University of Technology Sydney
New Research Building
UTS Blackfriars Precinct
2-14 Buckland Street, Chippendale NSW

State Significant Development SSD 6746
Stage 1 Development Application (Use
and Envelope)

Response to Submissions

Figure 3 Midwinter afternoon - Solar Access - Extracts from H2o solar study: 1pm (left), 2pm (middle), 3pm (right), existing (top row), proposed (bottom row)

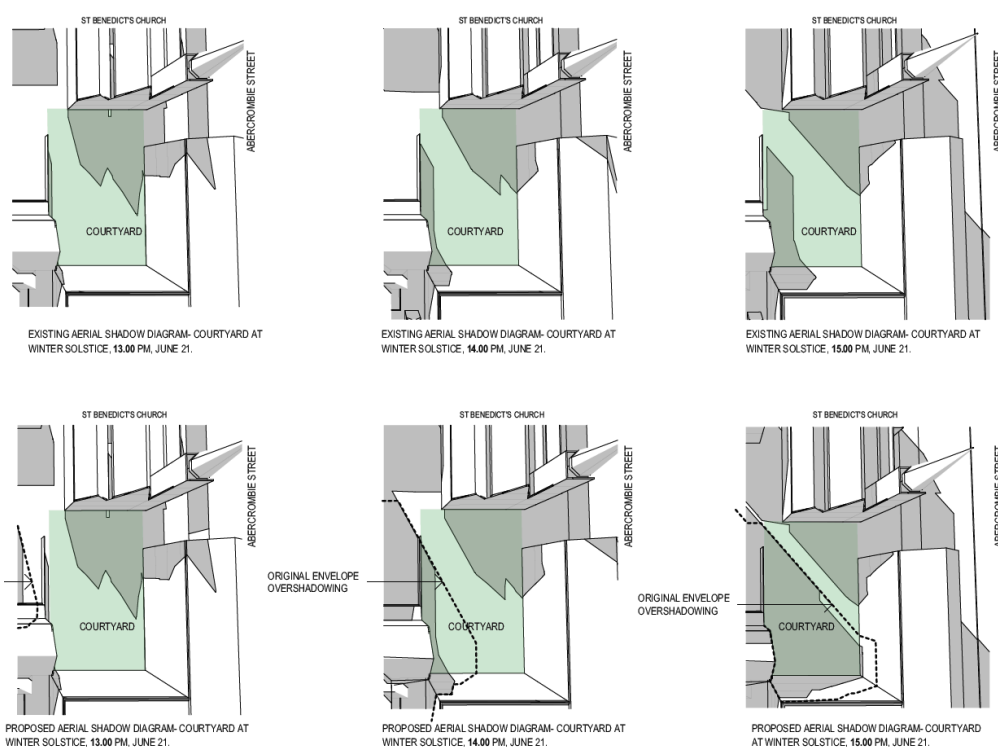
The Department has advised that it considers that the overshadowing from the proposed building envelope would have adverse amenity impacts on the Grafton Street/Buckland Street properties and the building envelope should be reduced or mitigation measures identified to ensure that a minimum of two hours of solar access is retained to all habitable areas during midwinter between 9 am and 3 pm for all residential properties impacted by overshadowing from the envelope.

The Department considers that the overshadowing from the proposed building envelope would have adverse impacts on the courtyard of the adjoining University of

Notre Dame Campus. A further overshadowing analysis, including consideration of the cumulative overshadowing impacts from the recently approved residential/serviced apartments (Block 4N) approved on the former Carlton United Breweries site must be provided. The overshadowing analysis must demonstrate that the courtyard area would have adequate solar access during mid-winter between 9 am and 3 pm.

In relation to the adjacent UNDA campus courtyard, UTS has significantly reduced the extent of the proposed envelope in order to address impacts. The UNDA courtyard is an internal private open space to the south of the St Benedicts church and east of the boundary with UTS. The envelope has been set back from the UNDA boundary at the upper levels and reduced in height in order to reduce overshadowing impacts. This is demonstrated in the accompanying envelope shadow diagrams, drawing A1.09 at Appendix 6. This drawing specifically focuses on the UNDA courtyard and shows the existing midwinter shadows in the courtyard and the additional shadowing that would arise from the proposed envelope at 1pm, 2pm and 3pm. The proposed envelope does not create any additional overshadowing of the UNDA courtyard in midwinter until after 2pm. There are no shadow impacts arising out of the proposal on the UNDA courtyard in the morning or during a typical lunchtime break.

The diagrams demonstrate that the UNDA courtyard will retain its very good existing levels of solar access at 1pm and 2pm with approximately 50% of the courtyard area having solar access. The other 50% is overshadowed by the UNDA's own buildings, principally the St Benedicts Church. This period is considered to be the most important time of the day for retaining solar access as it coincides generally with lunchtime and will provide for the enjoyment and use of the courtyard during the lunch break in midwinter.

Between 2 and 3pm, the existing shadows cast by St Benedicts Church, the high brick boundary wall, the UTS former boys school heritage building (CB25) and the other UNDA buildings on Broadway overshadow approximately 50% of the

courtyard area. The proposed development will reduce the solar access to the courtyard over this hour, causing the southeastern corner of the courtyard to be overshadowed approximately 30 minutes earlier than it would otherwise be from existing buildings. At least approximately 15% of the courtyard will retain solar access until at least 3pm. After approximately 3.15pm the courtyard will be in full shade.

Figure 4 Midwinter Morning - Solar Access - Extracts from Block 4N shadow study: 10am (top), 11am (middle), 12 noon (bottom)

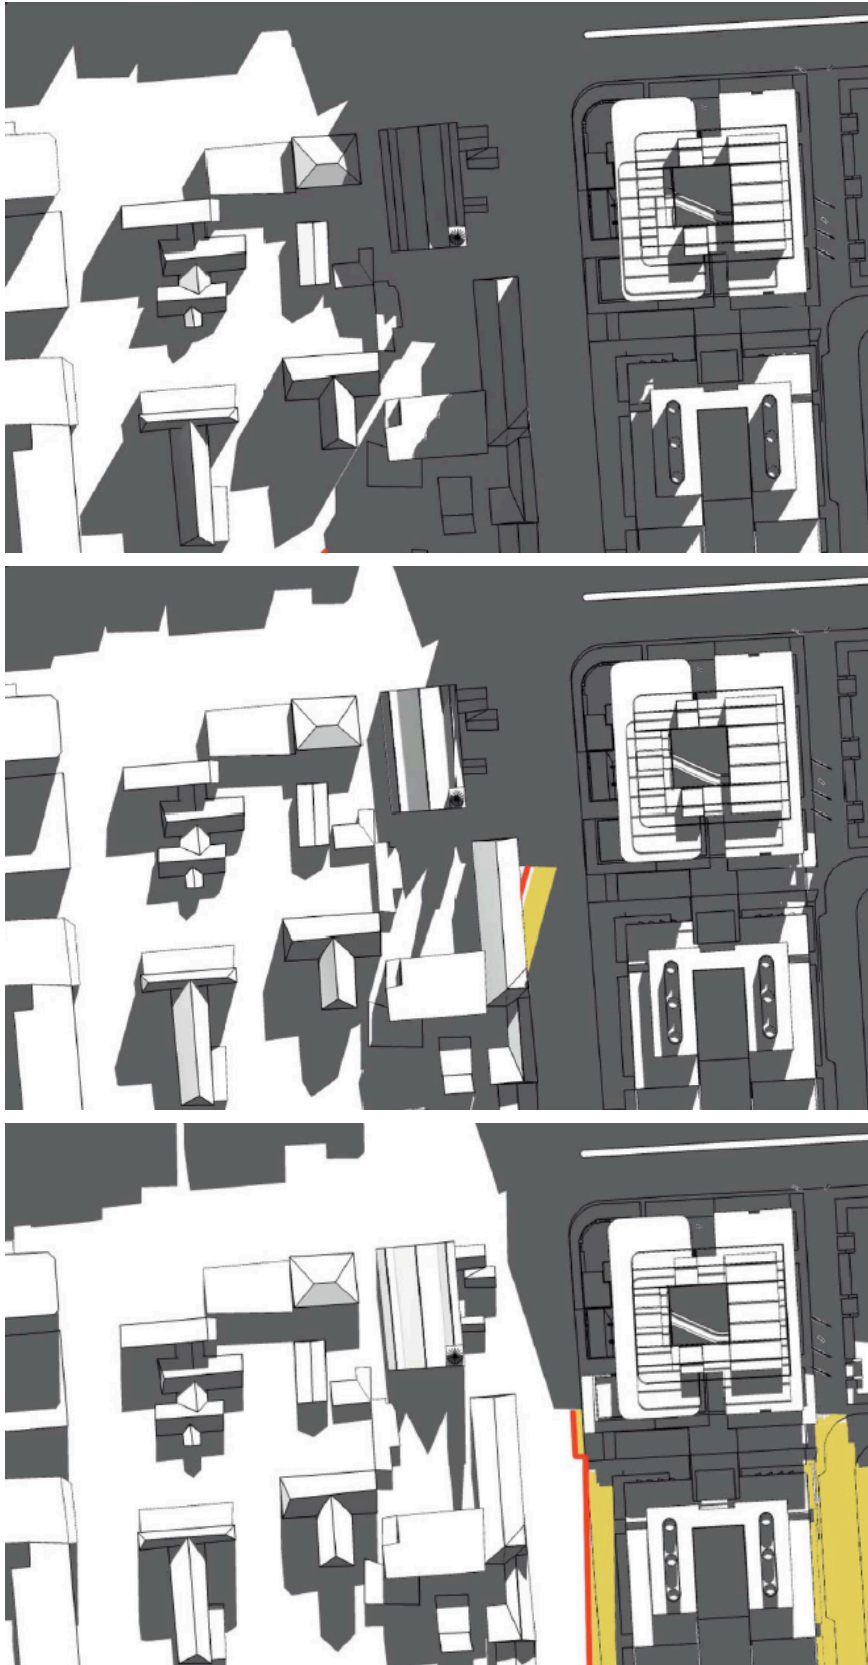
The Department has requested that the cumulative impact of shadows from the approved Block 4N of the Central Park development SSD6673 be considered in relation to the UNDA courtyard. Block 4N is a 16-19 storey mixed use building at the corner of Abercrombie Street and Broadway, part of the former Carlton United Brewery site, consistent with the Frasers CUB Concept Plan (Part3A) MP 06_0171. The approved drawings for Block 4N include shadow diagrams for midwinter at hourly intervals (Drawings PA-A4-1303 through 1305 Block 4N Shadow Studies, prepared by Foster + Partners and PTW Architects). A copy of the relevant drawings sourced from the Department's Major Projects website is provided at Appendix 5, and an extract reproduced at Figure 4.

The Block 4N shadow studies show that the UNDA courtyard (like much of Chippendale) is completely overshadowed in midwinter until shortly before 10am, when approximately 25% of the courtyard space in the southwest corner begins to receive sunlight. By 11am the Block 4N development is no longer overshadowing the courtyard, and approximately 50% of the courtyard has solar access.

Accordingly, taking into account the cumulative impact of shadows from the Block 4N development and the revised UTS proposal:

- There will be no change to the existing solar access to the UNDA courtyard between 11am and 2pm
- The UNDA courtyard will have some midwinter solar access from approximately 9.45am until approximately 3:15pm
- Approximately 50% of the UNDA courtyard will have midwinter solar access for 3 hours between 11am and 2pm

Taking into account the cumulative impact of shadows, it is considered that the UNDA courtyard will continue to have good midwinter solar access with no impact on its existing solar access at the critically important lunchtime period. The impacts arising out of the proposed development are limited to after 2pm, and are considered to be minimal and reasonable, particularly considering the dense urban context. As a result, it is considered that the UNDA courtyard retains a good level of solar access, that is reasonable for its context, particularly taking into account the standards which apply to comparable spaces (shared/communal private open space) elsewhere in Sydney and NSW.
